Re: Response to Comments on Updated Groundwater
Modeling Report
Claremont Polychemical Superfund Site
SAIC Project 01-1633-04-5386-552

UPDATED GROUNDWATER MODELING REPORT FOR THE CLAREMONT POLYCHEMICAL SUPERFUND SITE

OLD BETHPAGE, NEW YORK

February 2011

Figure 3-9. USGS/MODFLOW/MT3D Predicted PCE Plumes in 5 Years for Zone C-Upper and Zone C-Middle
Plume Map Contour Interval = 5, 10, and 100 ug/L
Predicted PCE concentration was below 5 ug/L in Zone C-Lower layer

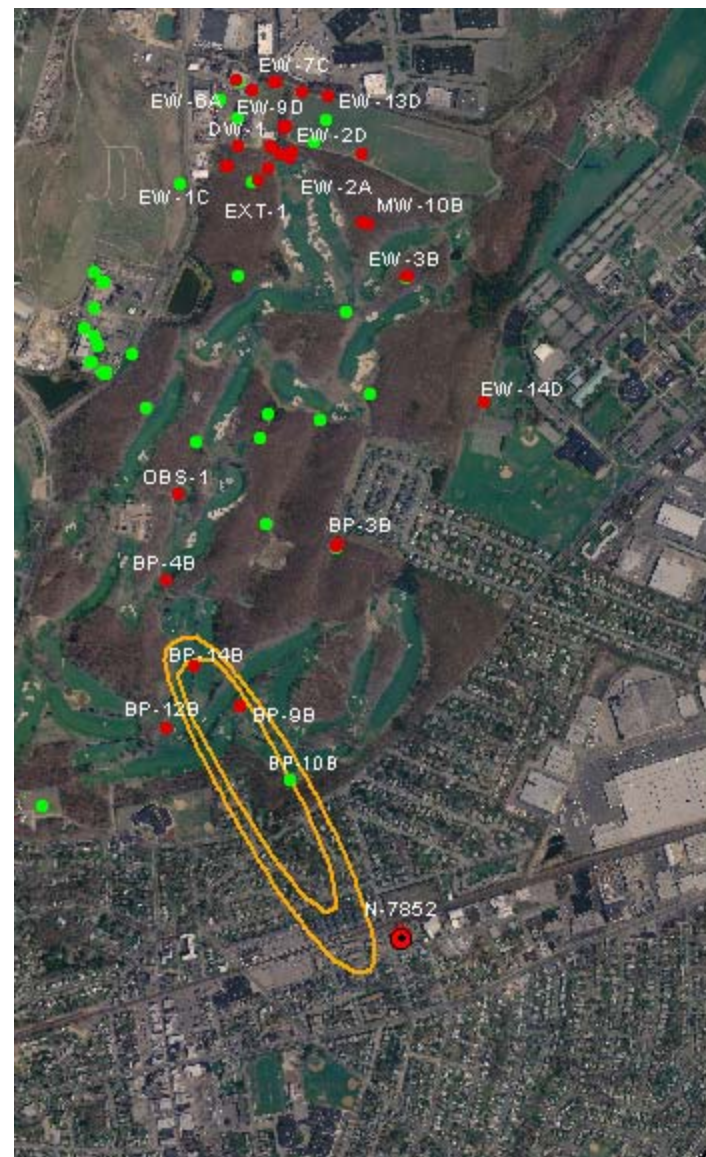
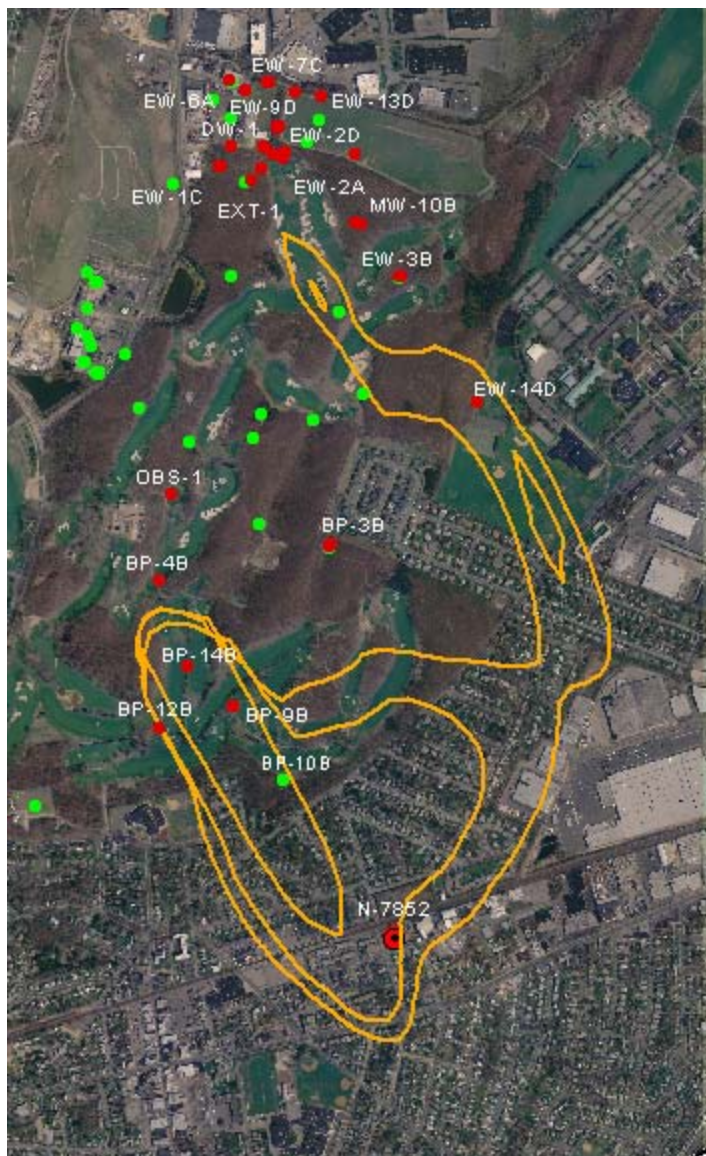
3. Page 15, paragraph 2, 3.2.5.1. The results of the solute transport modeling of the PCE Plumes are presented in **Figures 3-8, 3-9, 3-10, and 3-11**; the text reads Figures 3-6, 3-7, 3-8, and 3-11, please correct.

Concur. *Figures 3-6, 3-7, 3-8, and 3-11* have been changed to *Figures 3-8, 3-9, 3-10, and 3-11*.
